# Human Factors Evaluation of Control Room Design and Operator Performance at Three Mile Island - 2

Final Report

Three Mile Island Special Inquiry Group

U.S. Nuclear Regulatory Commission

**FIGURE 8**  
**PRESSURIZER HEATER CONTROL AND DISPLAY ARRANGEMENT**

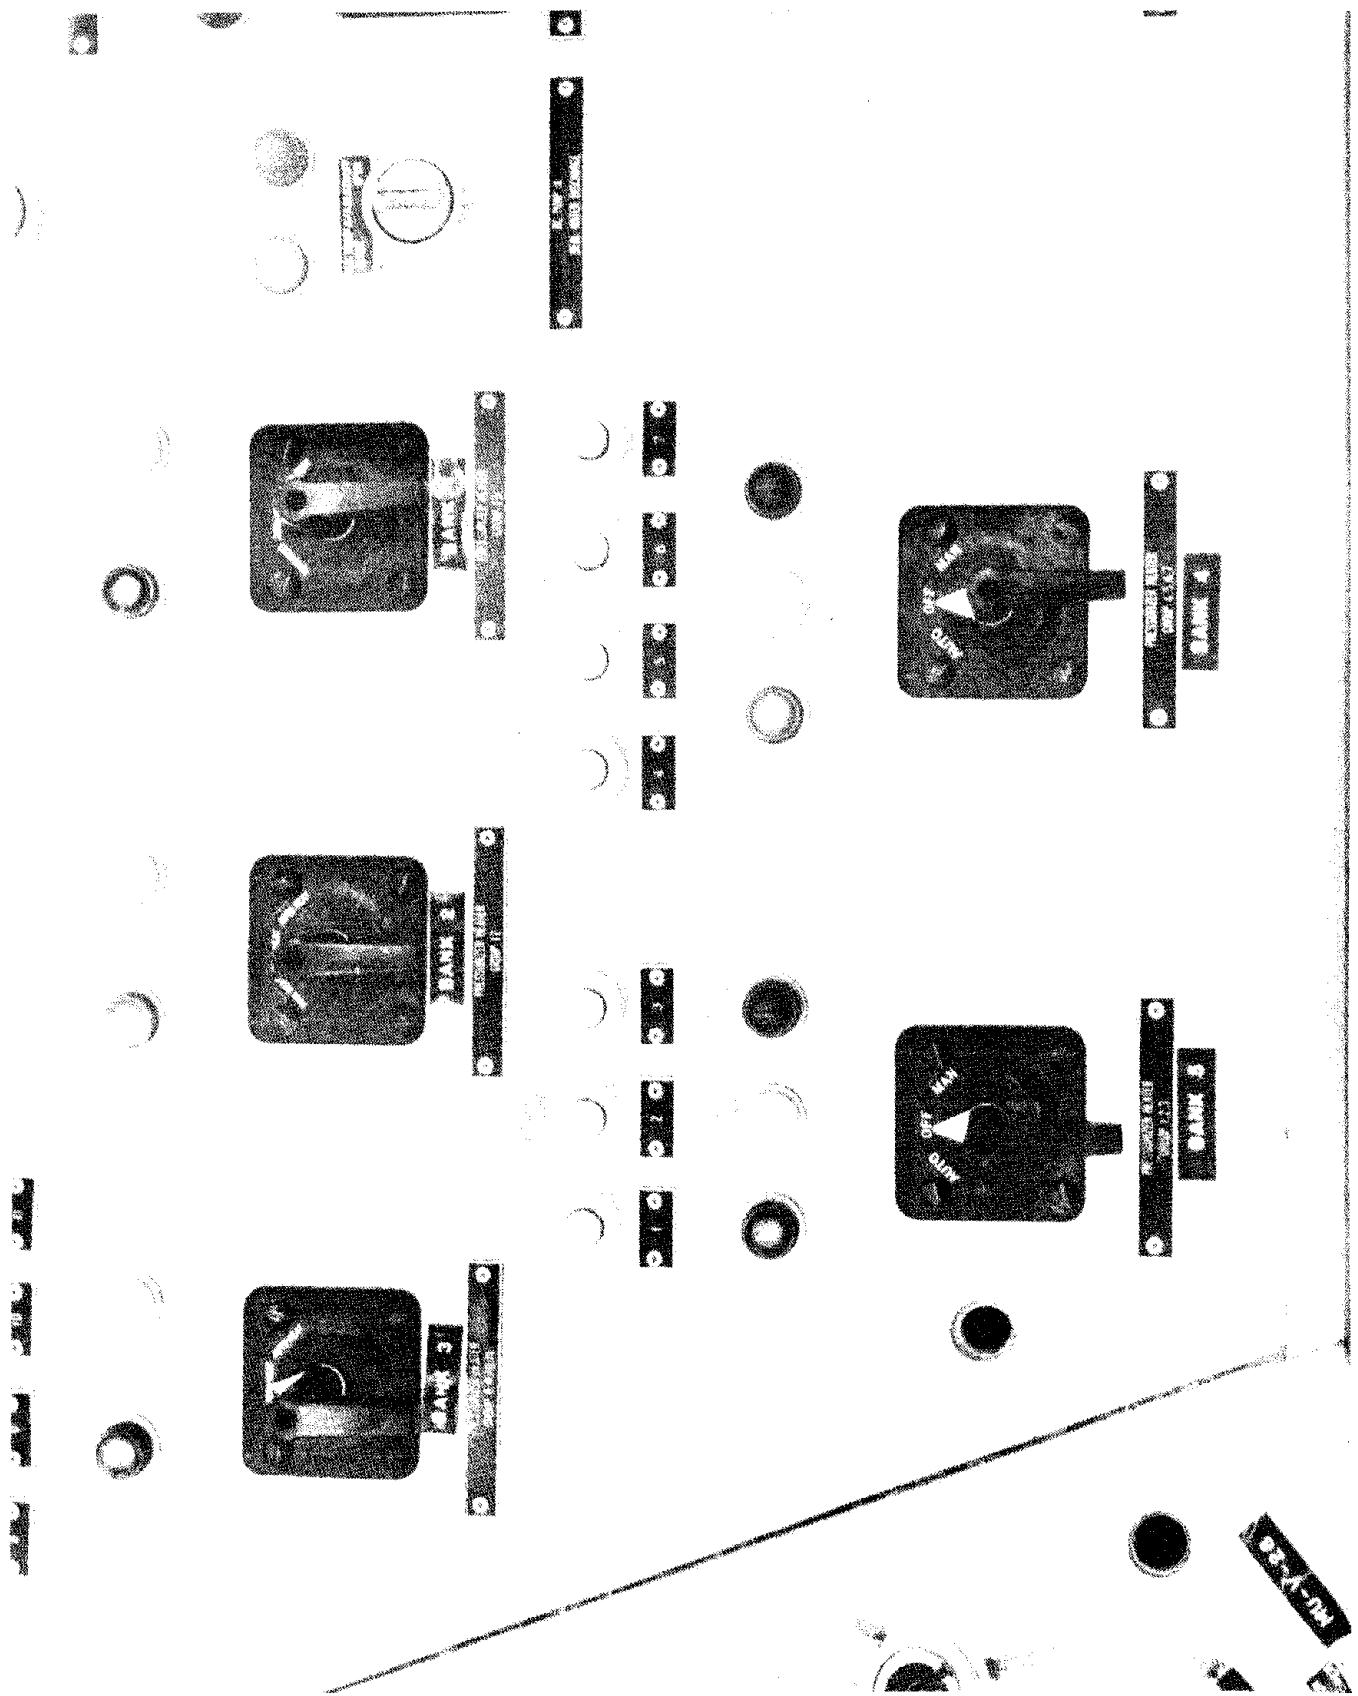
Workstation Design/Panel Layout — There are 5 "J-handle" switches provided for control of the 5 groups of pressurizer heaters. The arrangement of pressurizer heater controls is depicted below and in Figure 8.

Notice that the heater groups are not only organized contrary to convention (i.e., left-to-right, top-to-bottom), but the control positions for auto and manual modes are reversed, as well. Additionally, the control for the pressurizer spray has the auto mode in the center position. Such inconsistent and illogical panel layout increases both the operator's time to respond and the probability that he will commit an error.
